REPORT TO CITY OF VISALIA PLANNING COMMISSION

PROJECT PLANNER: Josh Dan, Associate Planner
Phone No.: (559) 713-4003
E-mail: josh.dan@visalia.city

Staff recommends approval of Conditional Use Permit No. 2019-36 based upon the project's consistency with the Orchard Walk Specific Plan, the General Plan, and the Zoning Ordinance, by adopting the findings and conditions in Resolution No. 2019-66.

Pad No.2 – Front Elevation

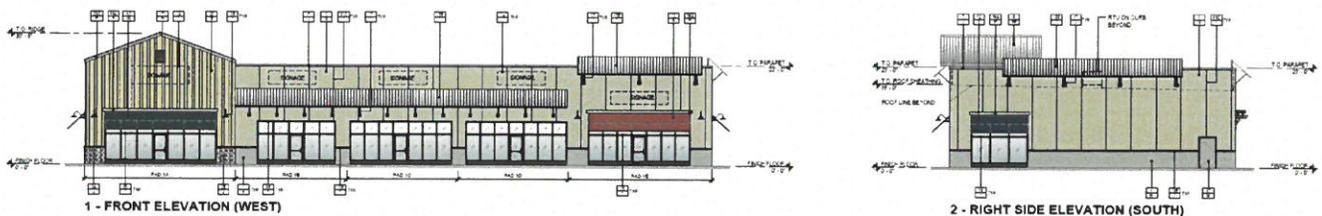
The Pad No. 2 elevation plans submitted for the In-N-Out Burger are not consistent with the architecture design guidelines written in the Specific Plan, which require the building facades to retain a rustic and pastoral theme. The applicant is therefore proposing an amendment to the Specific Plan's architecture standards for the In-N-Out Burger restaurant that would give them flexibility to allow for this building pad to be developed with their prototype building design that has strict corporate building elevation and material requirements for their In-N-Out Burger restaurants buildings. In-N-Out buildings are required to maintain their form of architecture that is found in every In-N-Out building located throughout the State.

Based on the amendment to the architecture standards to accommodate the In-N-Out Burger restaurant, staff recommends the Planning Commission approve this request based on the remaining balance of the In-N-Out site being developed with the amenities as required per the specific plan, including the wood split-rail fencing to be installed along the Dinuba and Riggan street frontages, bucolic landscaping, trellis covers, on-site lighting poles, etc. to maintain the overall cohesive appearance as required per the Orchard Walk Specific Plan.

Condition No. 3 has been included for the Planning Commission's consideration permitting Pad No. 2 to be developed with the elevations provided by In-N-Out as found in Exhibit "D", subject to the remaining balance of the Pad No. 2 site incorporating the Orchard Walk amenities including the wood split-rail fencing, bucolic landscaping, trellis covers, and other site amenities as contained in the Orchard Walk Specific Plan.

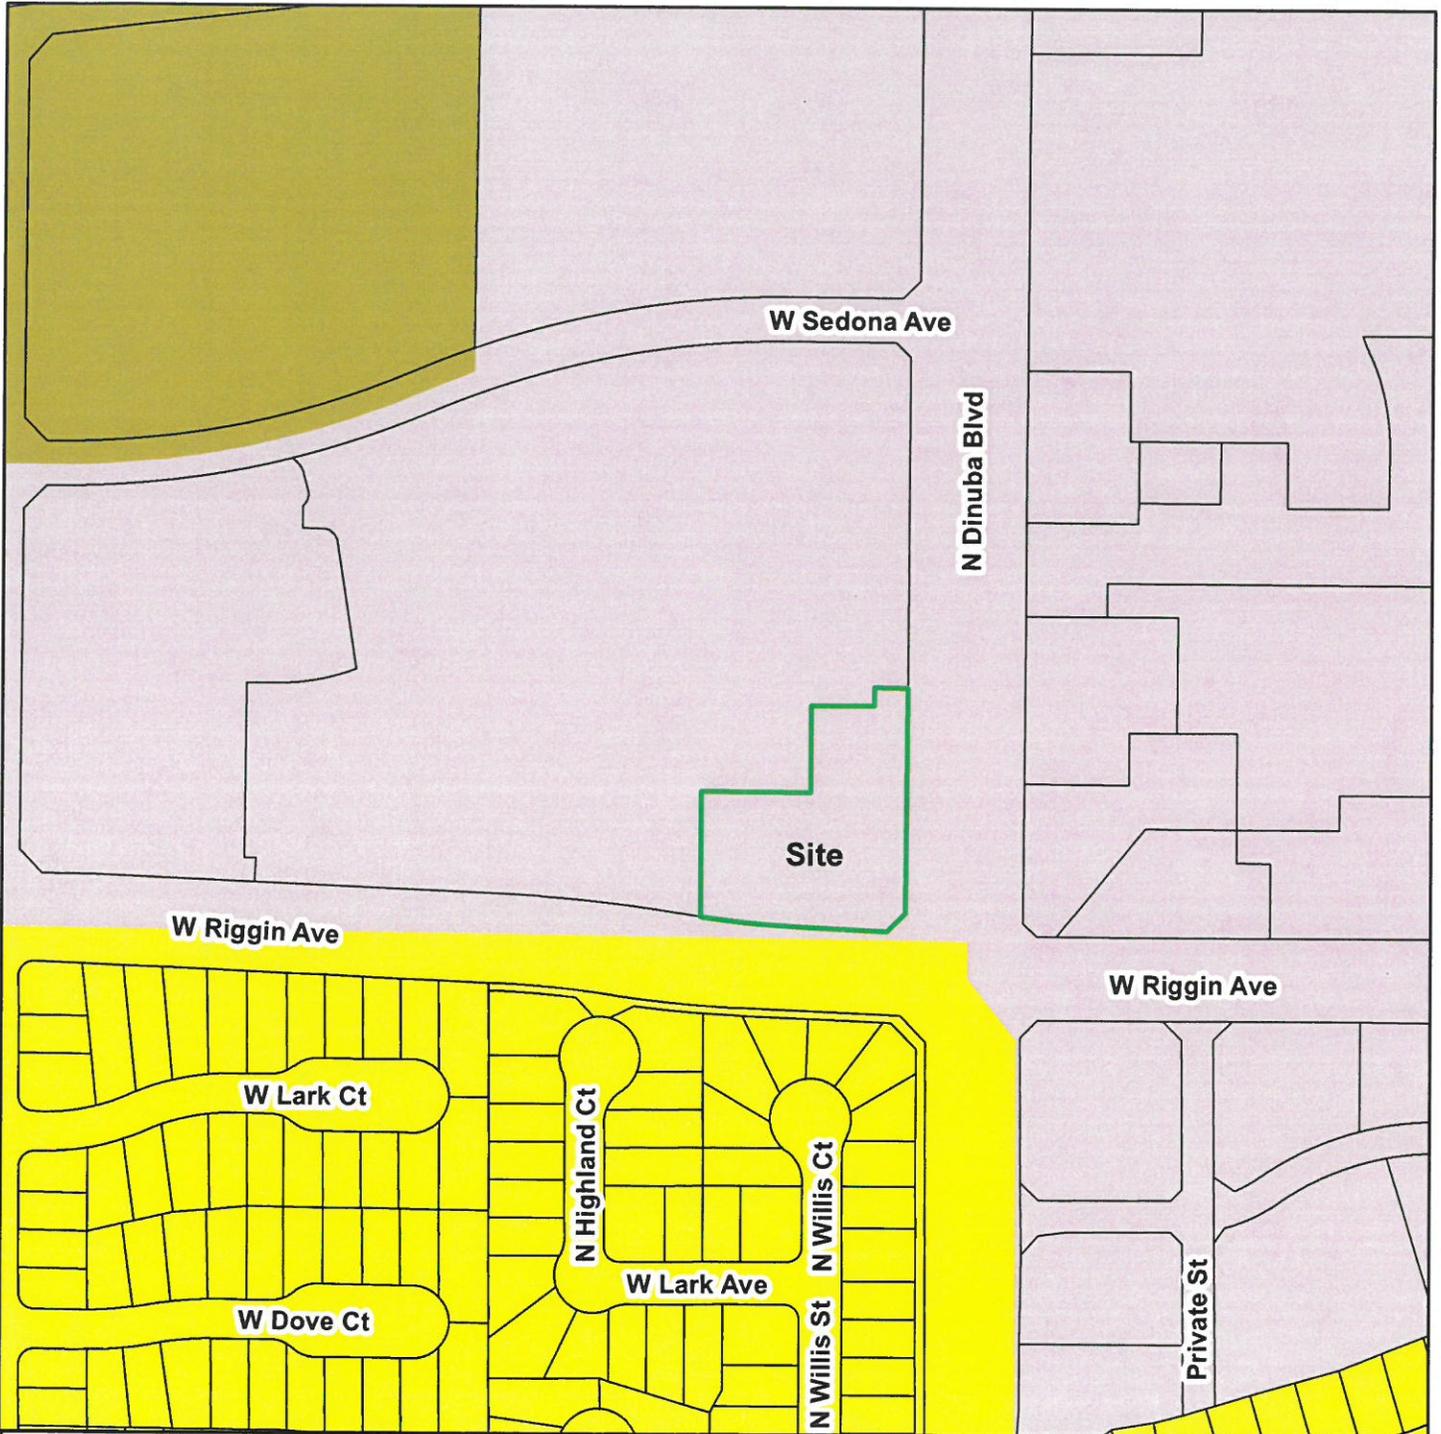
- Comment**
All bin enclosure are not acceptable. Need to avoid Landscape Islands at both location at PADS 1E and 3D. The enclosure at IN-N-OUT will have to be designed and located for a STAB service (DIRECT ACCESS). Be sure to have enclosure gates open 180 degrees. All gates must be equipped with chain bolts to secure them from closing. Solid Waste will not roll these bins out for service. 1000 gallon grease traps will be required for restaurants and grease traps are not allowed inside the enclosures.
